HKS PROJECT NUMBER
16246.000

ISSUE
CCD-049

SHEET TITLE
ROOF PLAN

SHEET TITLE
**ENLARGED
FACADE
ELEVATIONS**

SHEET NO.
AX2.12D

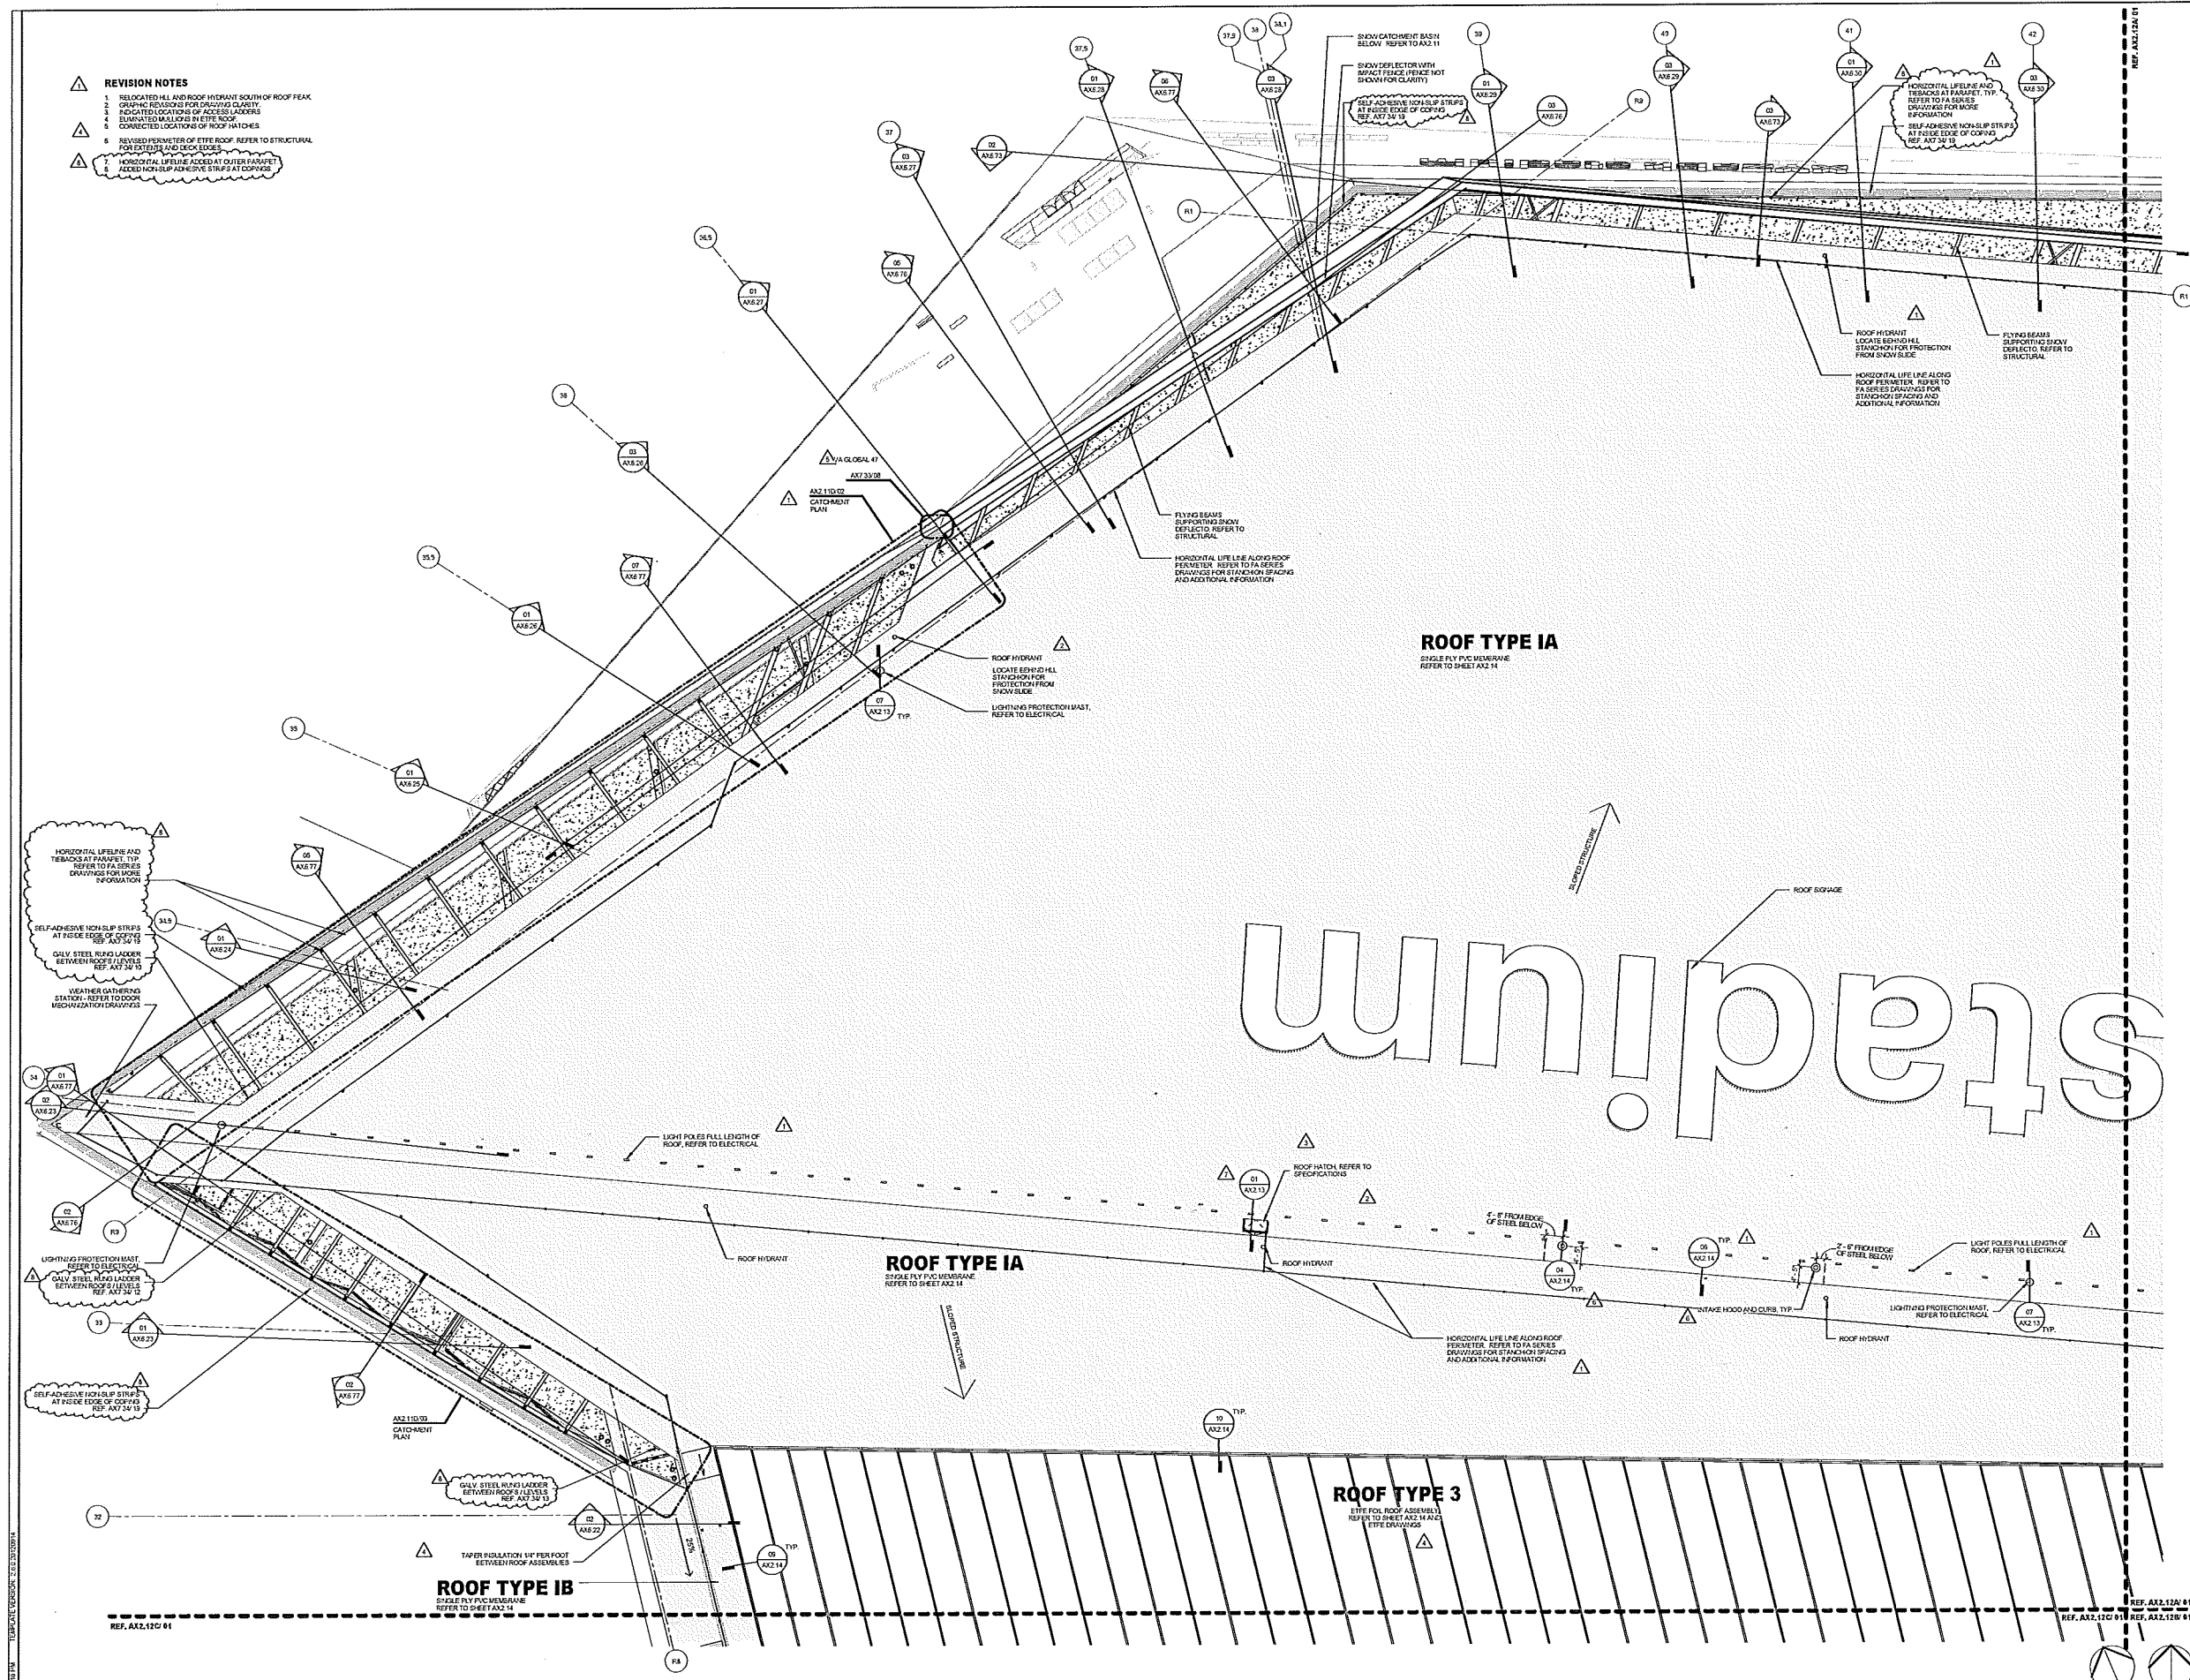
- REVISION NOTES**
1. RELOCATED HILL AND ROOF HYDRANT SOUTH OF ROOF PEAK
 2. GRAPHIC REVISIONS FOR DRAWING CLARITY
 3. LOCATED LOCATIONS OF ACCESS LADDERS
 4. ELIMINATED MULLIONS IN EYE ROOF
 5. CORRECTED LOCATION OF ROOF MATCHES
 6. REVISED PERIMETER OF EYE ROOF. REFER TO STRUCTURAL FOR EXTERIOR AND DECK EDGES
 7. HORIZONTAL LIFE LINE ALONG ROOF PERIMETER. REFER TO FA SERIES DRAWINGS FOR STATIONING SPACING AND ADDITIONAL INFORMATION

1 WEST PERIMETER TRUSS (PT-W1) - WEST ELEVATION
1/8" = 1'-0"

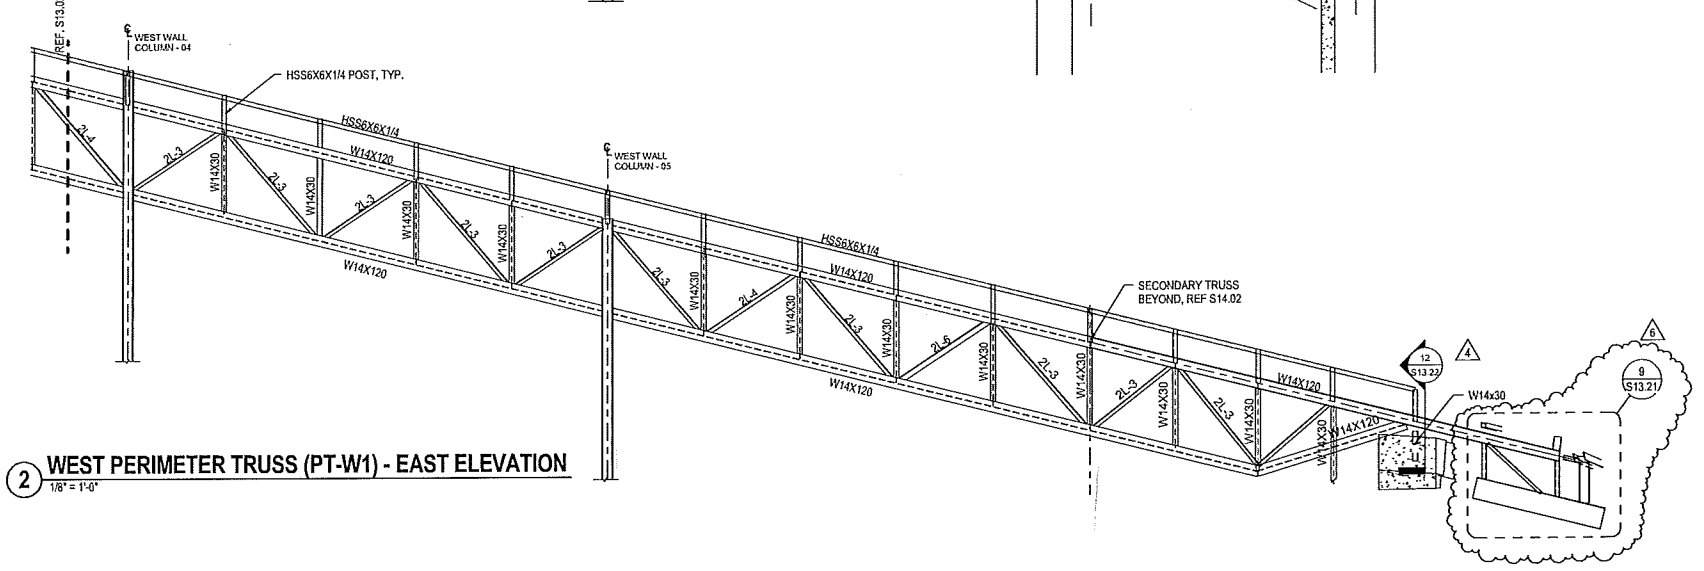
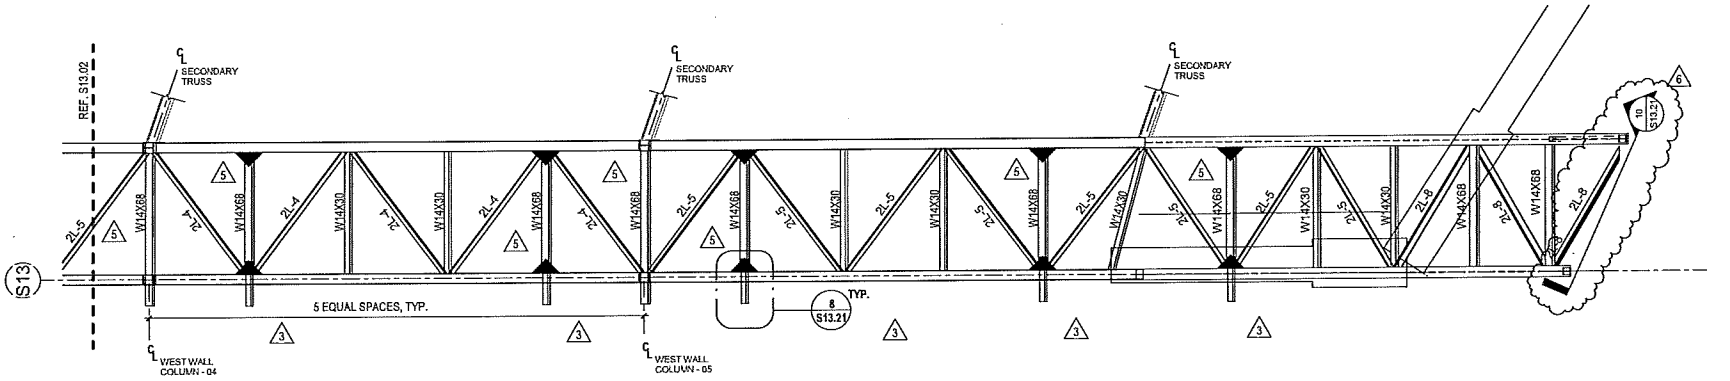
* CONTRACTORS OPTION TO PROVIDE 2L-6x4x7/8 PER RFI-0039.
